AGENDA
DESIGN COMMISSION
Commissions Room - 2nd Floor
Arlington Heights Village Hall, 33 S. Arlington Heights Rd.
Arlington Heights, IL 60005
September 8, 2026
6:30 PM

REPORT OF PROCEEDINGS OF A MEETING
BEFORE THE VILLAGE OF ARLINGTON HEIGHTS
DESIGN COMMISSION

RE: 515 SOUTH CHESTNUT AVENUE – SF/TEARDOWN - DC #26-051

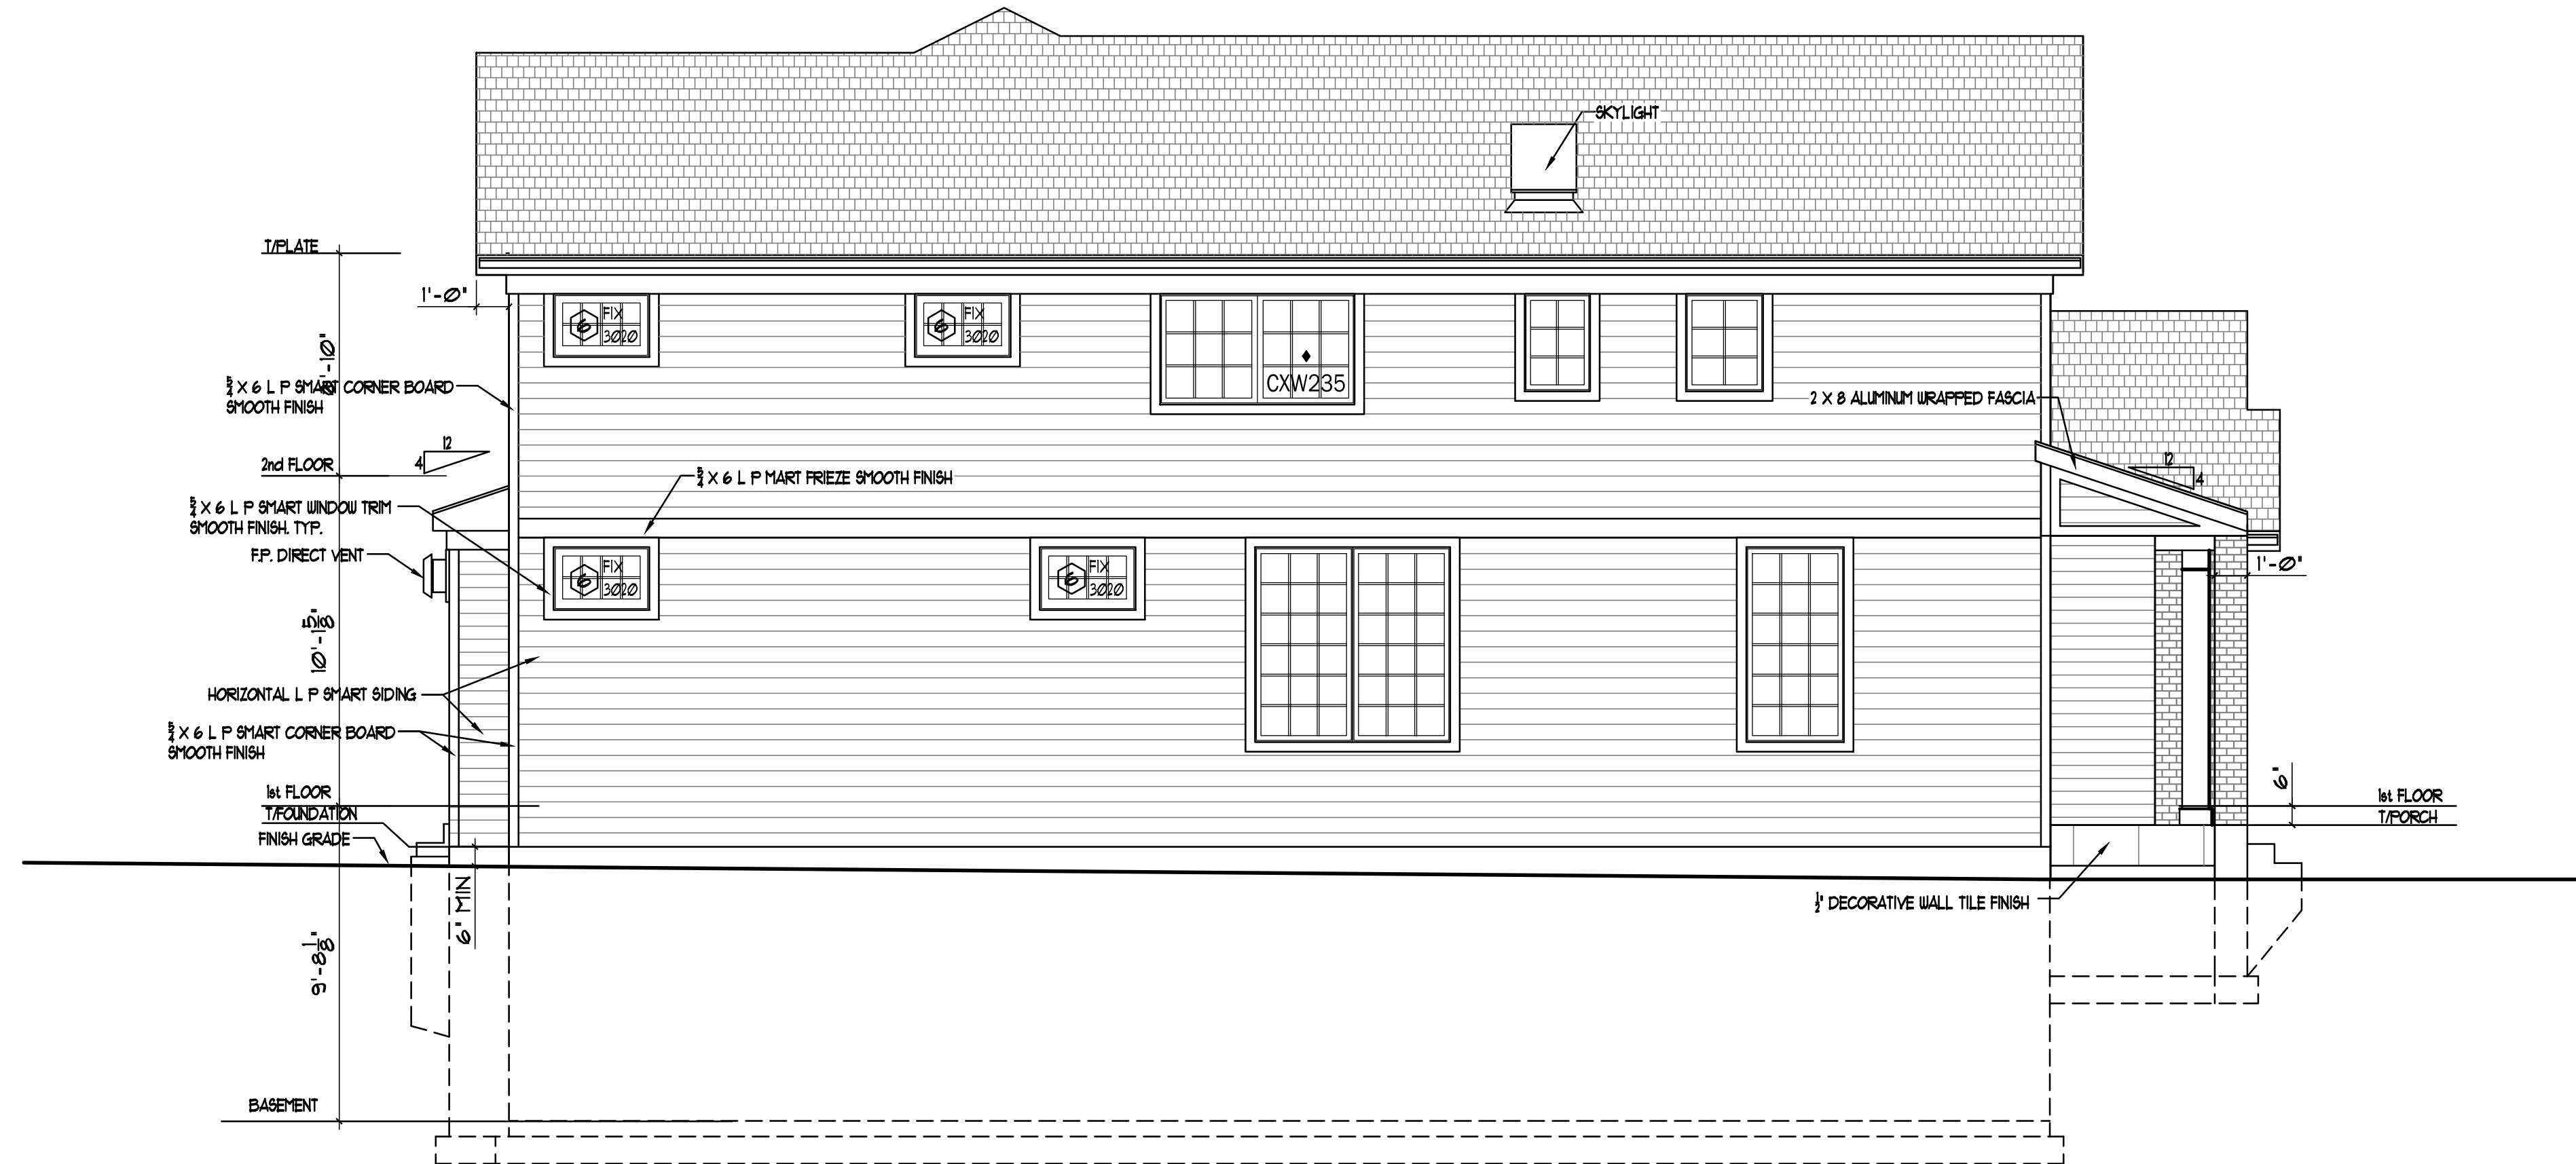
I think my suggestion to the Petitioner would be to lower that garage and maybe even considering some additional detail. I think even that gable might look better with a sided look instead of it being all brick, because it would break up this heavy mass of just a big plane of brick on the front. The reality is it probably would save you some money.

So, those are my comments. I think to summarize them, it is lower the garage, maybe change the material in that gable, get rid of the big mass. I know you can't probably run a roof across that front because it's not going to match the other gables, right, you'd be matching architectural styles. You know, we've seen that with a lot of designs, you know, run another roof line across to break up that mass, but maybe changing the materials helps. Study that window, figure out whether it needs to be lowered or a different sized window or something more interesting. The banding and the color would be at this point a suggestion but I think we might have to have a little more conversation about that.

- The garage wall looked too flat. A material change in the garage gables was encouraged.
- The garage roof should be lowered.
- The round window on the front elevation looked too high.
- An earth-toned color palette was encouraged instead of gray and white.
- Lowering the overall wall height was encouraged.

- The double garage door has been changed to two separate single garage doors with a 12" jog in the plan to reduce the footprint and to break up the flat wall.
- Garage wall height was lowered from 12'-0" to 9'-8".
- Garage roof slope was decreased from 7:12 to 6:12.
- The garage gable wall material was changed from brick to board and batten siding.
- The second floor wall height was reduced from 8'-1" to 6'-10" (1'-3" reduction), and the second floor window sizes have been decreased accordingly.
- All roof slopes were decreased from 7:12 to 6:12.
- The overall height of the house was decreased from 24'-10" to 22'-11 3/8" (1'-10 5/8" reduction).
- The round window was eliminated.
- The decorative window shutters were omitted.
- A continuous horizontal trim board was added near the second floor line around sides and back of house to break up the siding.

NORTH ELEVATION

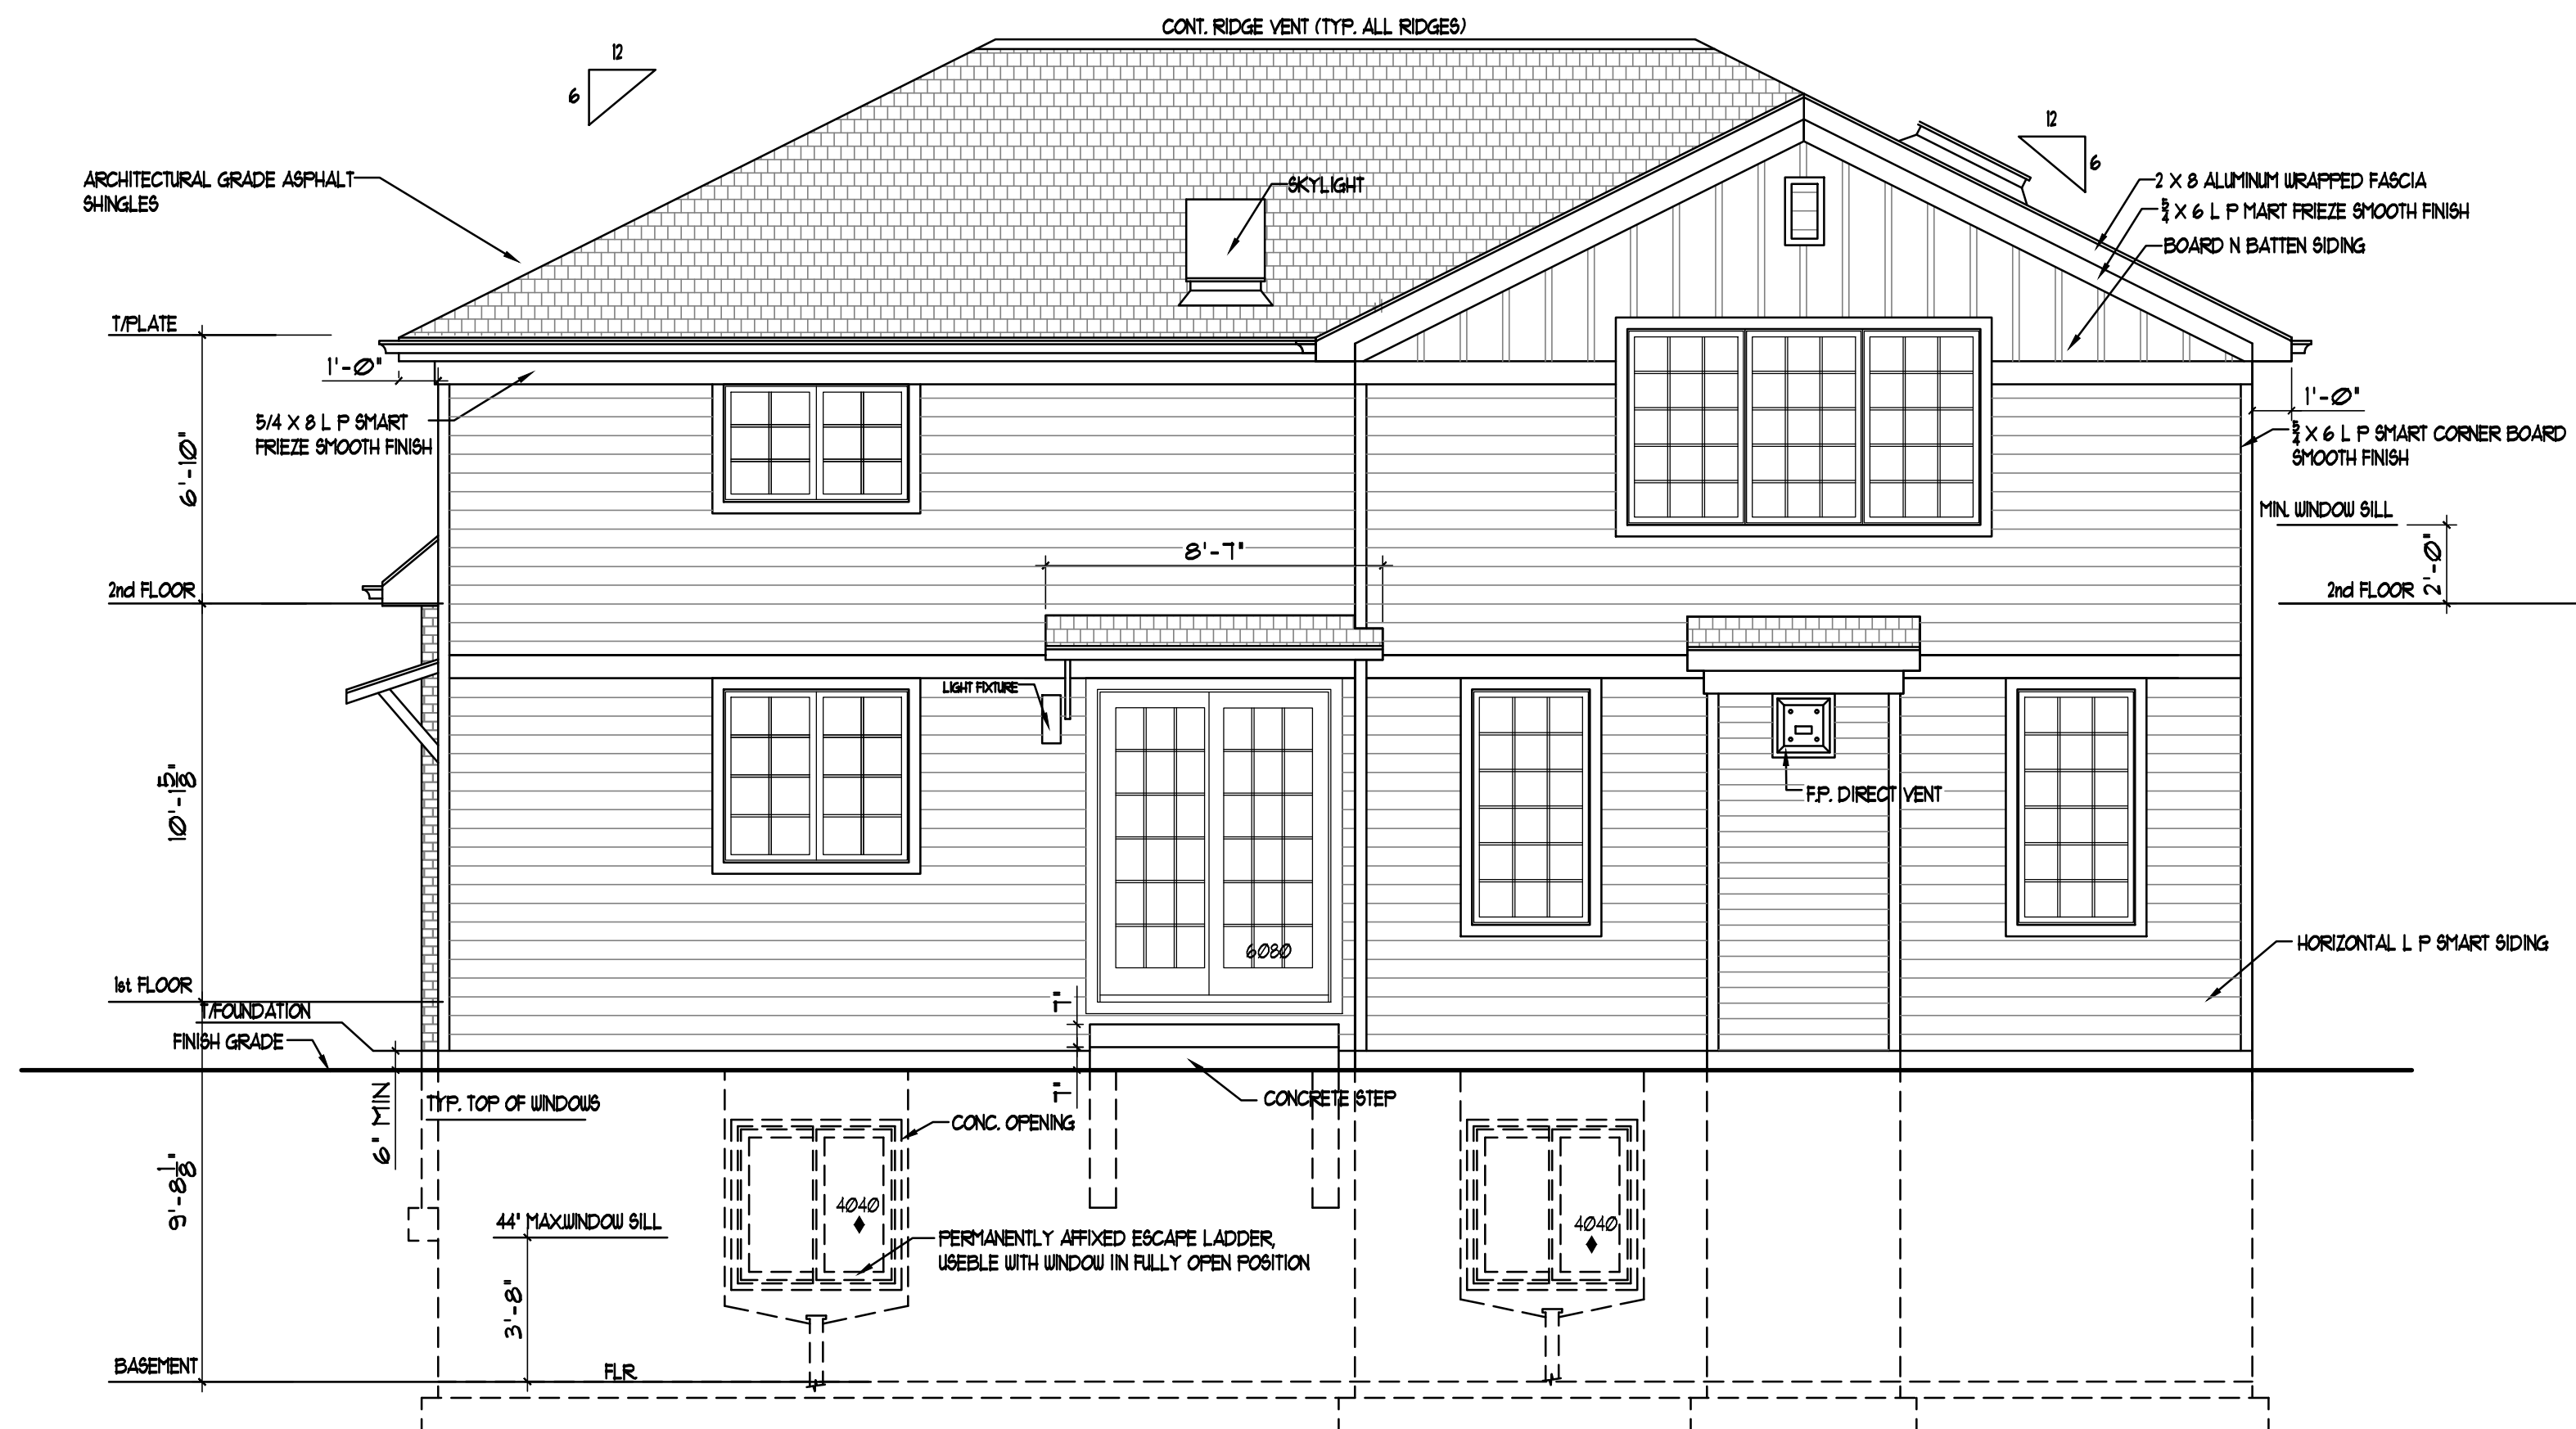
Secondly, or I should say finally, this is just a small detail, I suspect maybe it was just a drafting error, but on the north wall of the proposed home, there is this trim board that runs along the second-floor line. That's a nice detail to break up an otherwise just a tall, flat two-story wall. Introducing that trim board is a nice way to break that up. It will be like a white trim board against the contrasting color of the siding. But where the drafting error I think came in is it does not continue across the back or up the other side. So, we'll see what the Petitioner says about that, but Staff's recommendation would be if you're going to have that trim board on the north wall, which I would encourage to keep that detail, it should really wrap around the whole house and continue up this side as well. It would come right across like the garage eave there.
